## Draft Groundwater Sustainability Plan – Public Comment Responses

**Re: Response to Draft Groundwater Sustainability Plan (GSP) Comments**

**Re: MGA Response to Draft Groundwater Sustainability Plan (GSP) Comment Letter**

Figure 1: Figure 2-45 from the draft GSP (left panel) and a slide from the Surface Water Working Group meeting on January 30, 2019 (right panel). Red boxes show the period of the SC-18A hydrograph that was altered.

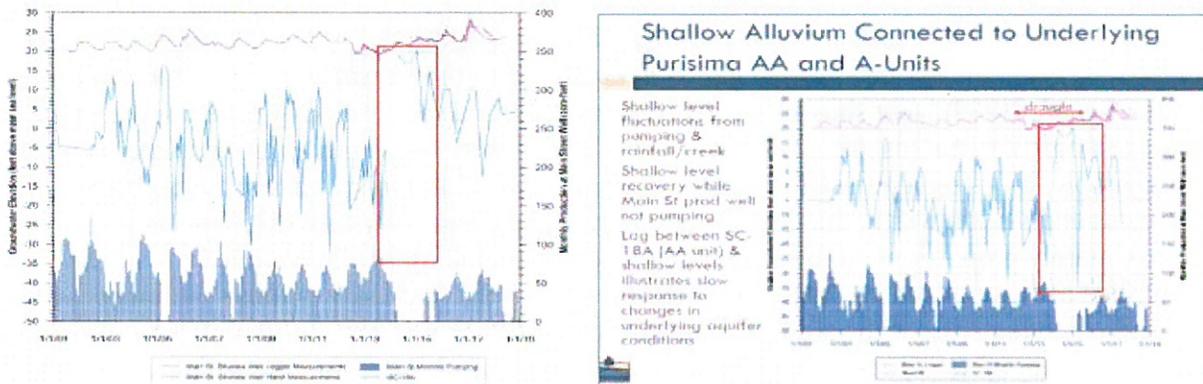
*Comment 12: Page. 2-121 - Figure 1 (left panel) below [from Surface Water Working Group materials] shows Figure 2-45 from the draft GSP. One of the hydrographs from this figure corresponds to monitoring well SC-18A (screened in Purisima AA- unit). During a Surface Water Working Group meeting on January 30, 2019, there was a presentation file...[that] showed a different hydrograph for monitoring well SC-1 8A (Figure 1, right panel). In fact, in a follow-up email after that meeting, a member of the Surface Water Working Group noted that there was a considerable sharp decrease in SC-18A during spring/summer of 2015 (red box in Figure 1, right panel), and asked if it corresponds to a pumping interference or an historic low in groundwater levels for that well. There has been no reply to this question. Figure 1 (left panel) shows the hydrograph for monitoring well SC-1 8A that is presented in the draft GSP, but without the sharp decrease during spring/summer of 2015. We suggest [the MGA] address the discrepancy between the two figures.*

Page 2-121: Figure 1 (left panel) below shows Figure 2-45 from the draft GSP. One of the hydrographs from this figure corresponds to monitoring well SC-18A (screened in Purisima AA-unit). During a Surface Water Working Group meeting on January 30, 2019, there was a presentation file called “SurfaceWorkingGrp\_Jan30\_2019\_Georgina.pdf”. This presentation showed a different hydrograph for monitoring well SC-18A (Figure 1, right panel). In fact, in a follow-up email after that meeting, a member of the Surface Water Working Group noted that there was a considerable sharp decrease in SC-18A during spring/summer of 2015 (red box in Figure 1, right panel), and asked if it corresponds to a pumping interference or an historic low in groundwater levels for that well. There has been no reply to this question. Figure 1 (left panel) shows the hydrograph for monitoring well SC-18A that is presented in the draft GSP, but without the sharp decrease during spring/summer of 2015. We suggest SCMCGSA address the discrepancy between the two figures.

Response: The figures presented to the Surface Water Working Group and as Draft GSP Figure 2-45 were confusing because data was included in the Surface Water Working Group figure that was not labeled in the legend and was not included in the Draft GSP figure. MGA’s technical consultants revised and renumbered this figure to GSP Figure 2-48, included additional available monitoring data, and corrected the legend to more accurately indicate the source of the data provided. The text

of GSP Section 2.2.4.6 that describes Figure 2-48 draws the same conclusions and was not revised in response to this comment.

Figure 34. Calibration Hydrographs at Main St. Shallow Well and Underlying Purisima A and AA Units

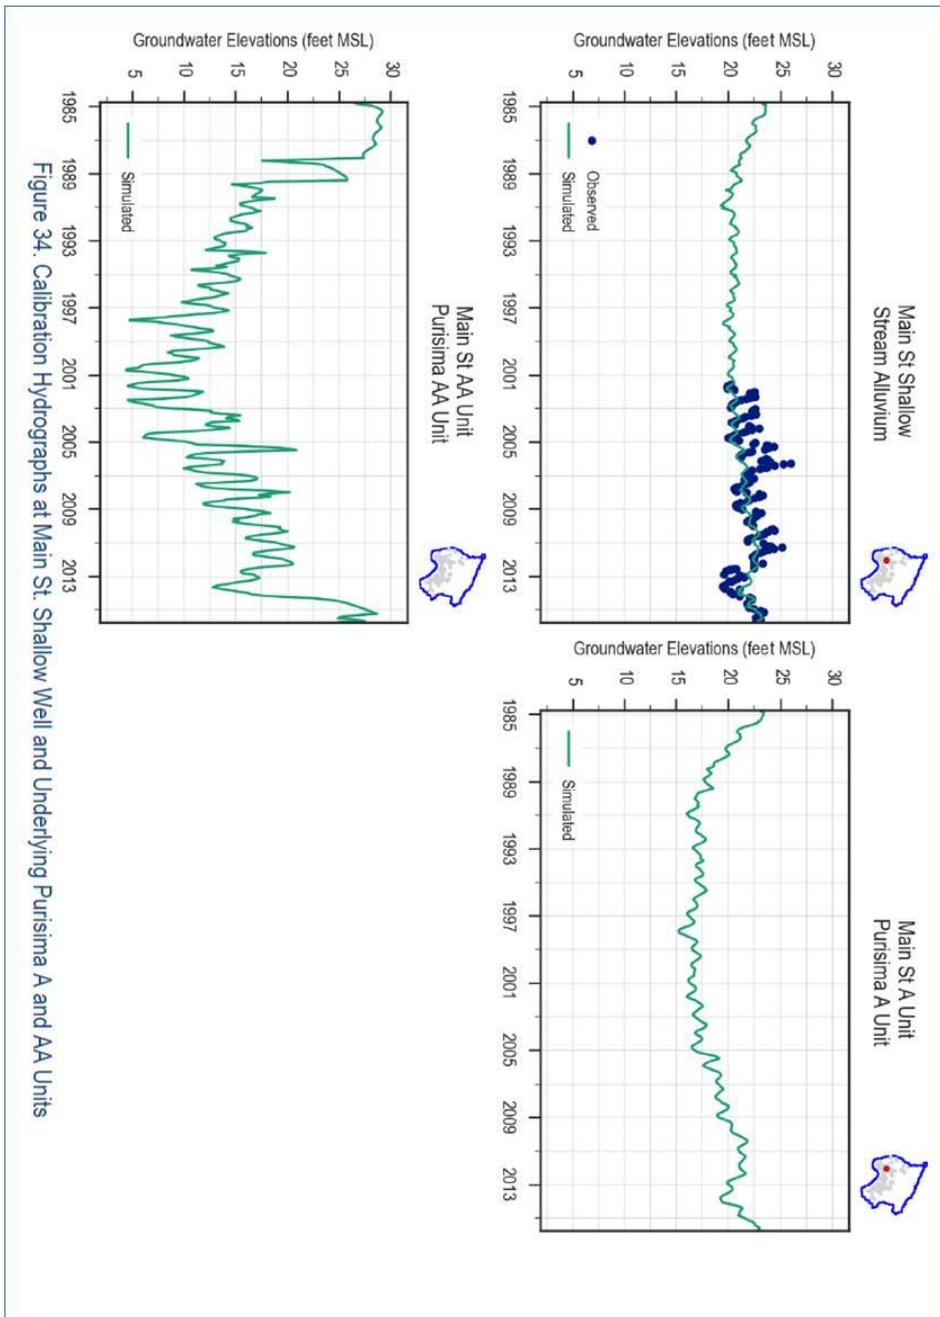
*appreciates the efforts to use the model to estimate impacts on Soquel Creek, the model seems to overestimate water levels when compared to observations during the dry years 2012-2015 in the Main St. shallow well (see figure 34 from calibration document below). It is concerning that the seasonal low levels were not accurately captured during this period as these are the most important levels to capture. This suggests that further refining of the model is needed to accurately model shallow well levels and predicted recovery from PWS and ASR projects. The mismatching of modeled results to real world observations could also be related to issues with the construction or location of the existing shallow wells as detailed in [additional comments] below.*
